**Falls Church Gateway  
500, 510 & 520 N. Washington Street**

500-520 N. WASHINGTON STREET | CITY OF FALLS CHURCH, VA | SPECIAL EXCEPTION PACKAGE

**Re** **Falls Church Gateway (Case 20070528)**  
**Staff Comment Response Letter**

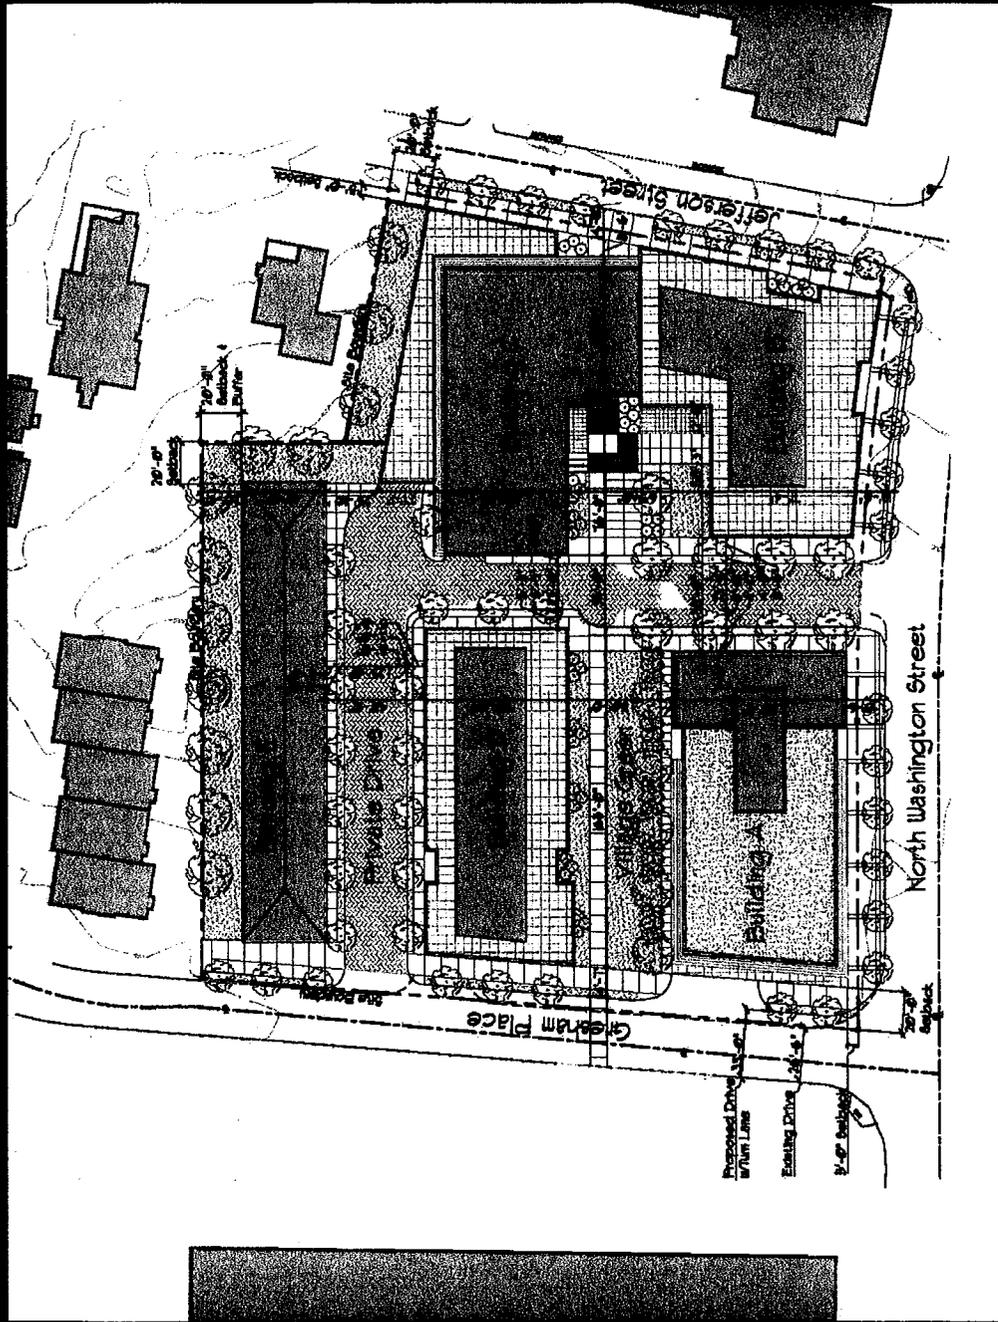
- 3) *On the drawing there is a blank space (27' 10" wide setback) on the right side in the back. What is this space for? Is it part of the "green area"?*

It is the dimension of the setback from the property at 111 East Jefferson Street. It will be landscaped green area.
